LINCOLN CITY/LANCASTER COUNTY PLANNING STAFF REPORT

*** REVISED NOVEMBER 1, 2016 ***

- PROJECT #:** Use Permit No. 16009 - Costco Center
- PROPOSAL:** Approval of a use permit for a 199,000 square foot commercial center.
- LOCATION:** South 14th Street and Pine Lake Road
- LAND AREA:** 40.58 acres, more or less
- EXISTING ZONING:** AG Agriculture District and R-1 Residential District
- CONCLUSION:** If the associated comprehensive plan amendment and change of zone applications are approved, this site is appropriate for commercial development as proposed, dependent upon the additional screening, trail crossing improvements, and other conditions of approval. This request complies with the Zoning Ordinance and is consistent with the Comprehensive Plan.

COVER / NOTE PLAN
 COSTCO CENTER
 USE PERMIT
 2016
 LINCOLN, NEBRASKA

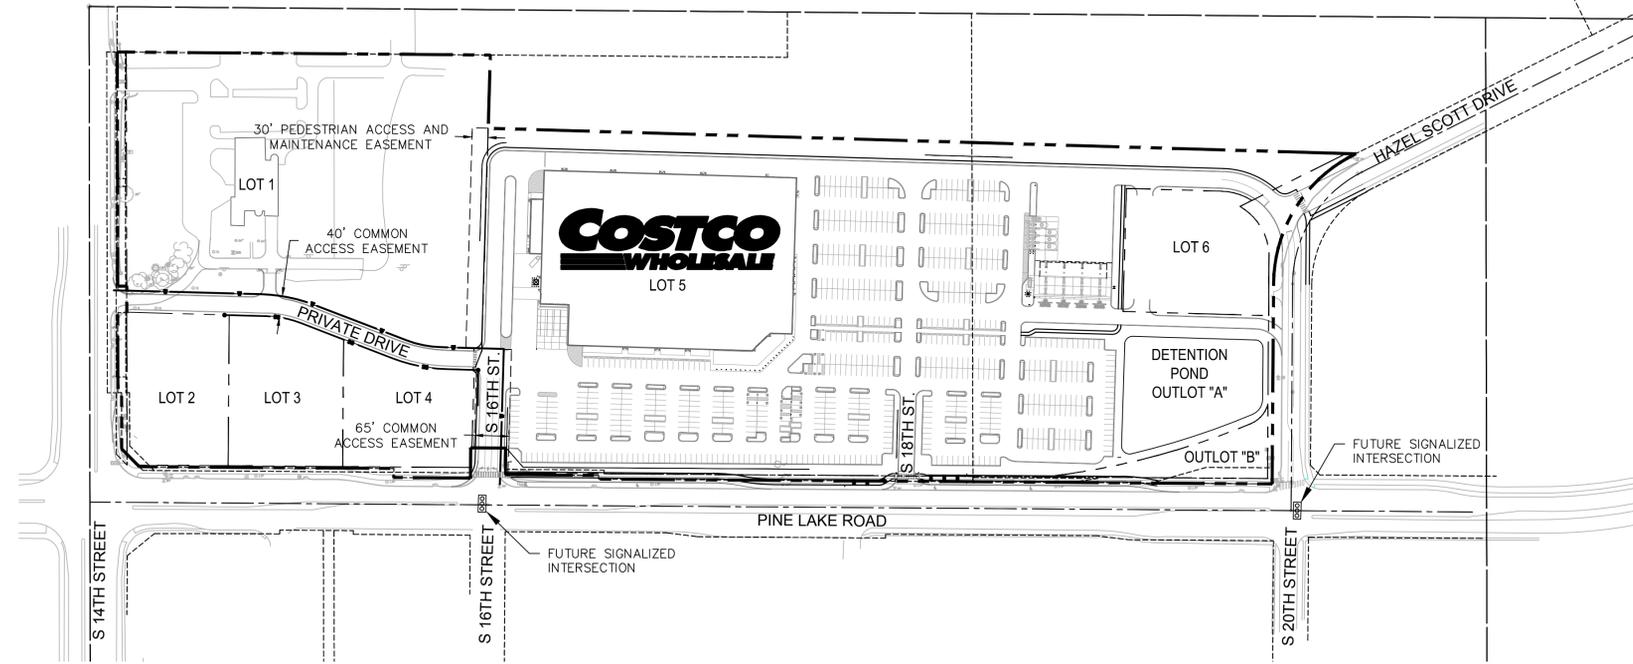
- 2.2 Make the following revisions to Sheet 1:
- 2.2.1 Revise Note 15 to read, "If the existing funeral home on Lot 1 redevelops into different commercial uses, the following is required: the northern driveway will be reconfigured to better serve the multiple commercial properties; a right hand turn lane will be required to the northern driveway on South 14th Street and the sidewalk relocated to provide adequate safety for pedestrians; all improvements, and right of way dedication, will be at the expense of the developer redeveloping the funeral home property; the south right-in/right-out access on South 14th Street shall be eliminated at that time; a 300-foot plus taper northbound right turn lane shall be required to be installed at that time for the north access point on South 14th Street; and a common access easement shall be provided over Lot 1 from South 14th Street along the new east-west driveway."

- 2.2.2 Revise the last sentence of Note 16 to read, "10 feet of additional right-of-way or easement will be dedicated/provided." Add the following text at the end of the note, "The bike trail shall be located a minimum of 10 feet behind back of curb to provide adequate separation and room for street trees. Street trees shall be installed six feet from the back of curb."

- 2.2.5 Revise Note 18 to read, “The buildings on Lot 5 shall substantially conform to the building elevations included in this use permit (sheets 6 thru 10) to the satisfaction of the Planning Director.”

2.2.9 Correct the Required Parking Stalls for Lot 1 to 74 and revise the Total Required Parking Stalls to 667.

SITE PLAN
COSTCO CENTER
USE PERMIT
 LINCOLN, NEBRASKA
 2016
 REVISIONS

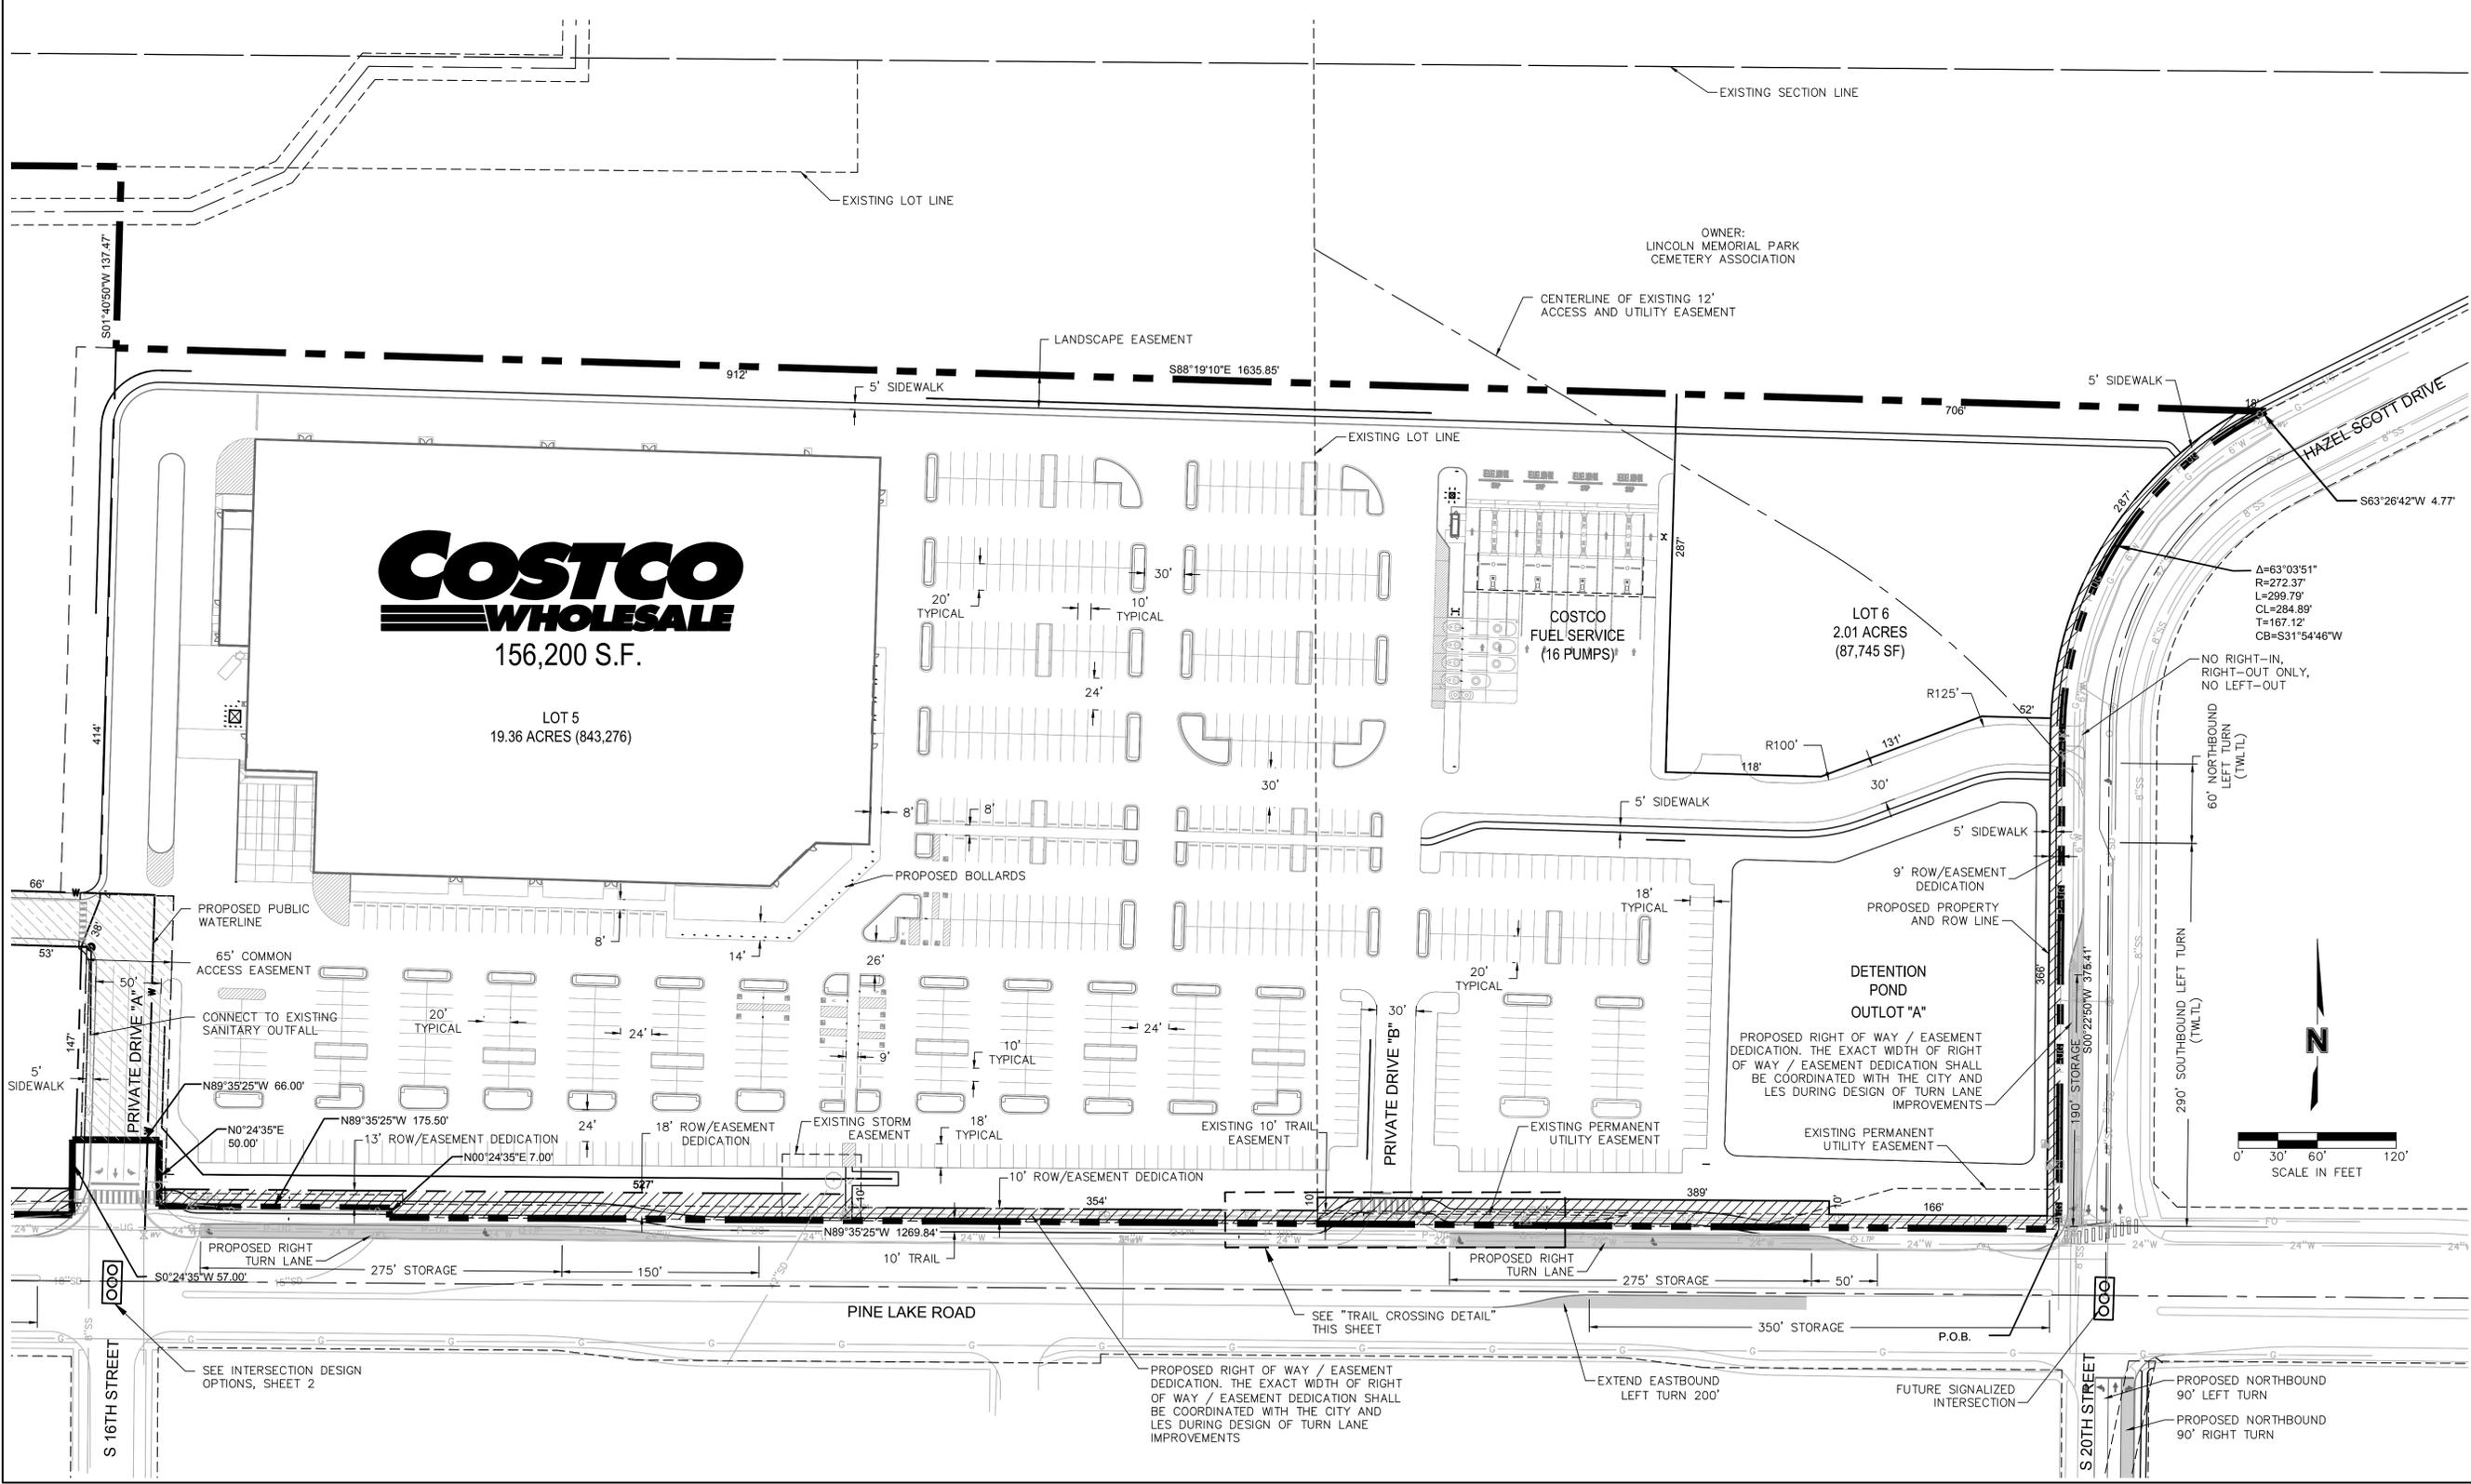
The site plan continues to show a traffic signal symbol at South 16th Street and Pine Lake Road. In addition, Sheet 2 now shows three "Intersection Design Options" at South 16th Street including a fully open option with a traffic signal, a fully open option with no signal, and three-quarter access (no left outs permitted). A traffic signal and fully open intersection without signal are not recommended or supported by the TIS. A signal at that intersection would not meet the Access Management Policy spacing requirements, and it is unlikely that such a signal would meet the minimum traffic warrants necessary to justify it. Public Works and Utilities continues to be supportive of the three-quarter access only at that intersection as recommended by the TIS.

- 2.1.3 At the intersection of South 16th Street and Pine Lake Road:
 - 2.1.3.1 Retain $\frac{3}{4}$ -access as proposed and recommended by the Traffic Impact Study. Remove the three Intersection Design Options at the top of Sheet 2.

- 2.1.3.2 Remove the traffic signalization symbol and the note for "Future signalized intersection".
 - 2.1.3.3 Show the vacation of part of the right-of-way stub on Private Drive A to the satisfaction of Public Works and Utilities.

GRADING & DRAINAGE PLAN

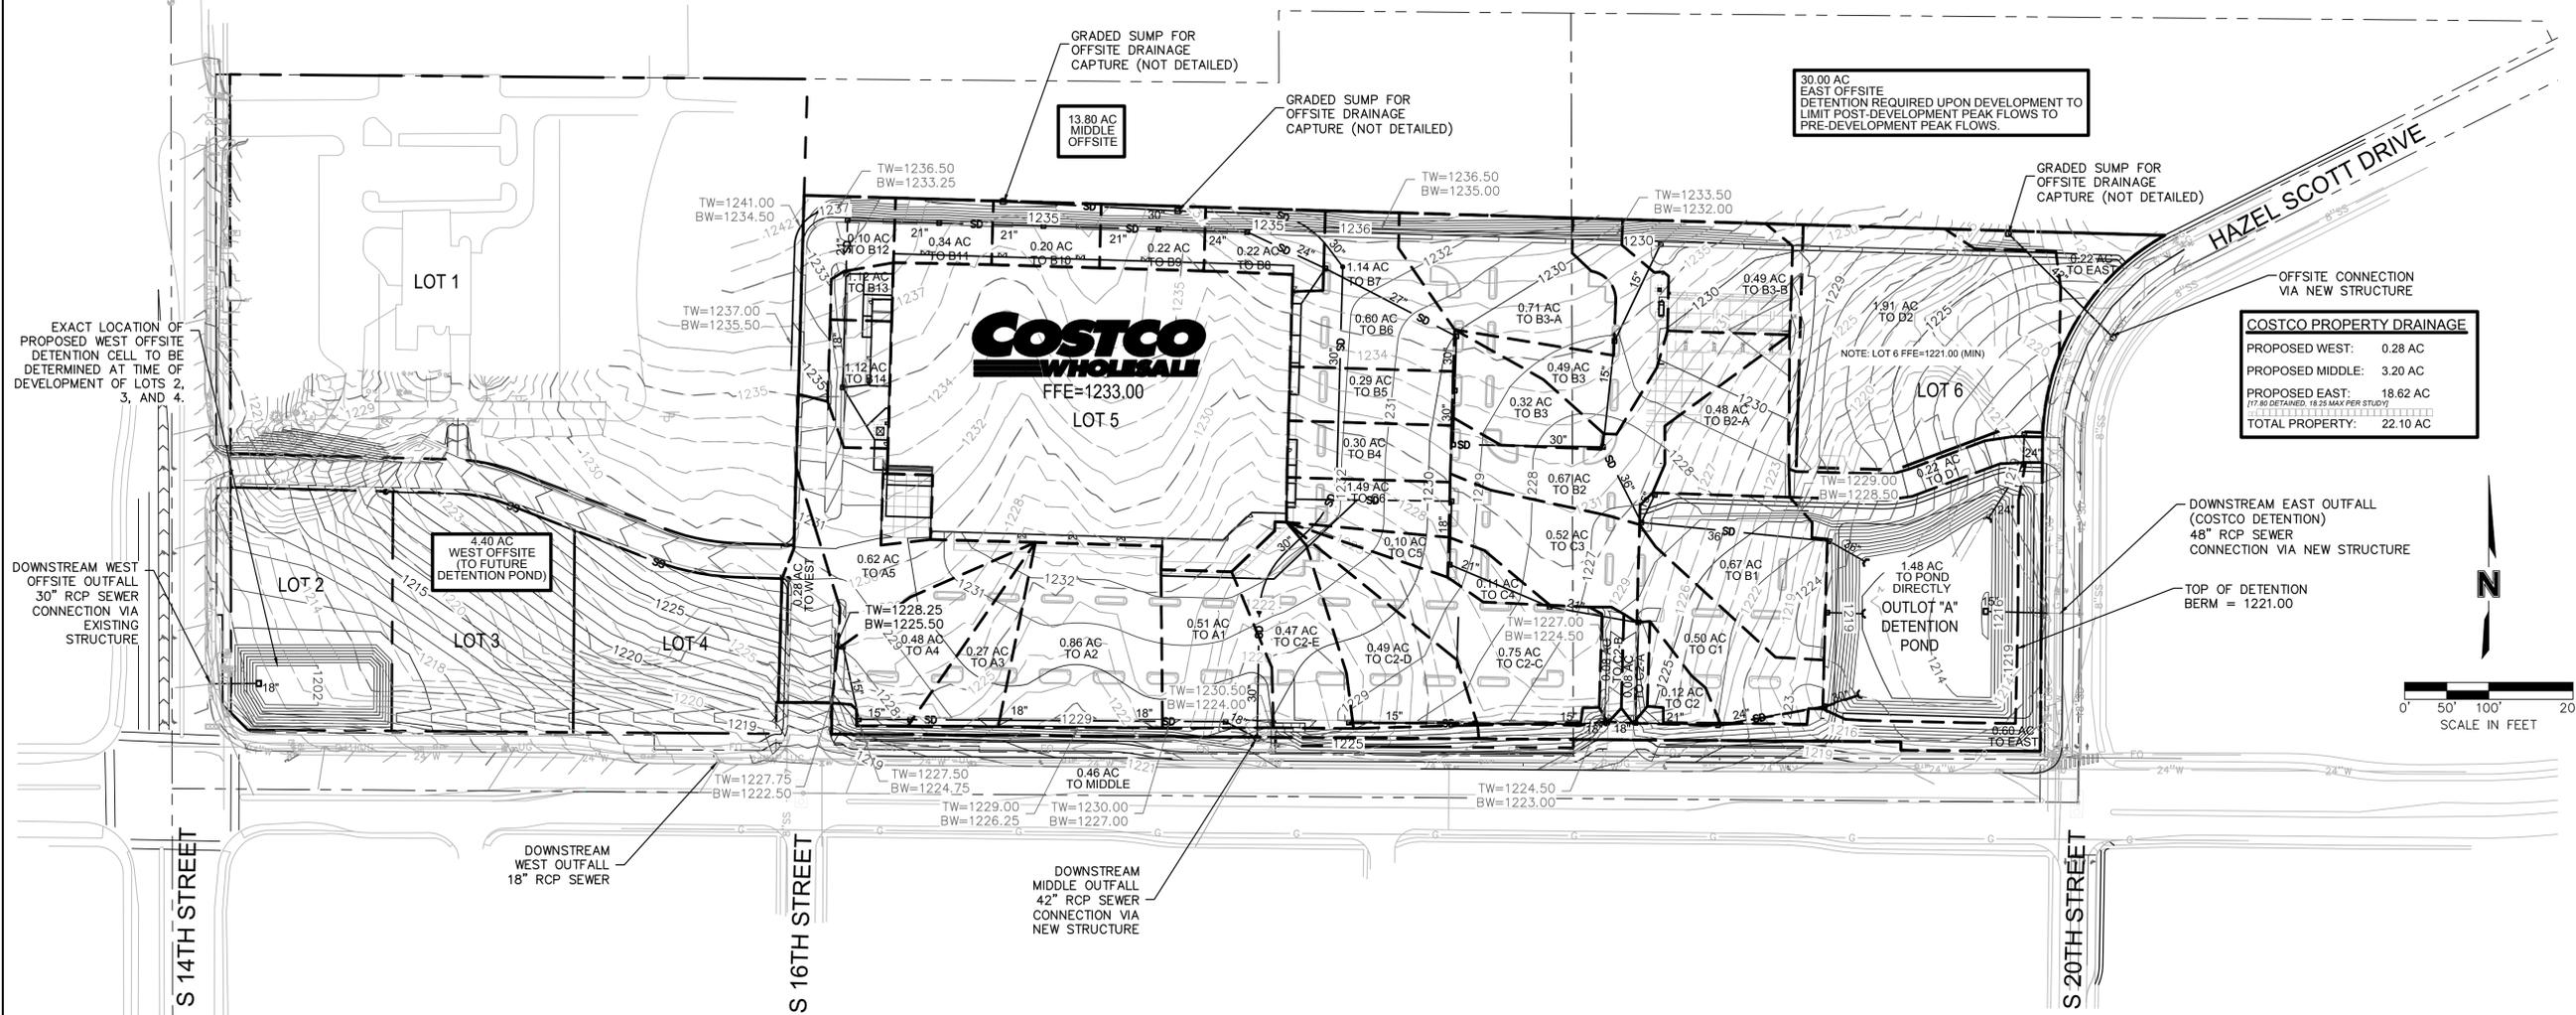
requirements. A maintenance agreement is not needed at this time, but will be required prior to Building Permit.	
		2	Corrections Required	<p>My first comment from the previous review has still not been addressed. This grading plan does not accurately represent the drainage areas, and is proposing grading outside the limits of the Use Permit. This means that the drainage report is also inaccurate because it is based on inaccurate drainage areas. This plan cannot be approved at this time because it is inaccurate. Furthermore, with the requirement to dedicate ROW at the southeast corner of the property for the potential roundabout at Hazel Scott Dr., the hesitancy to show the exact location of the West Detention Cell, and the inaccurate drainage areas, it appears there is not enough area on this property to meet the detention requirements. The following is a list of issues that need to be addressed before this plan can be approved:</p> <ol style="list-style-type: none"> 1. Revise the grading plan to show accurate drainage areas to follow the contours, not the property lines. Then revise the drainage report, using the accurate drainage areas. 2. Show how the 100-year is routed from the East Offsite and West Offsite areas. Any 100-year overland flow has to be in a flowage easement. 3. Existing East area leaves the site at the southeast end of the property through an existing 42" pipe. Proposed East Offsite area leaves the site at a different area. Please show how this change in outlet points will be handled. Does the existing storm sewer have the capacity to handle this new outlet point? 4. We need to see the exact location of the West Detention Cell. It is not acceptable to say the location will be determined at the time of development, and this detention cell should not be called "future". Also, this detention cell needs to either be on an outlot (similar to Outlot A) or be in an easement. 5. I mentioned this in my previous review – all detention cell side slopes need to be at a 4:1. Also, Parks and Recreation will need to review the location of the detention cell in relation to the bike trail to determine if it meets their clearance requirements. Typically we require a 10 ft buffer on all sides of a detention cell. 6. Plot out the 100-year ponding elevation for both 	Individual

<p>detention cells, making sure there is at least 1 ft of freeboard on all sides of the detention cells.</p> <p>7. The East Detention Cell needs to be reconfigured so that it does not conflict with the required ROW dedication for the roundabout at Hazen Scott Dr. The new location of the East detention cell closer to the existing roadway has also created possible conflicts with sightlines for vehicles on Hazel Scott Dr. with bicycle traffic along Old Cheney. Traffic will need to review this to verify if the location of the detention cell is acceptable.</p> <p>8. Revise Note 21 to say that the WQ maintenance agreement is the only thing that is not needed at this time, but will be required prior to Building Permit.</p> <p>9. Need to add a railing to the East Detention Pond outlet structure.</p>	
Public Works & Utilities - Wastewater	brian kramer	1	Recommend Approval	All lots appear to have sanitary sewer.	Individual
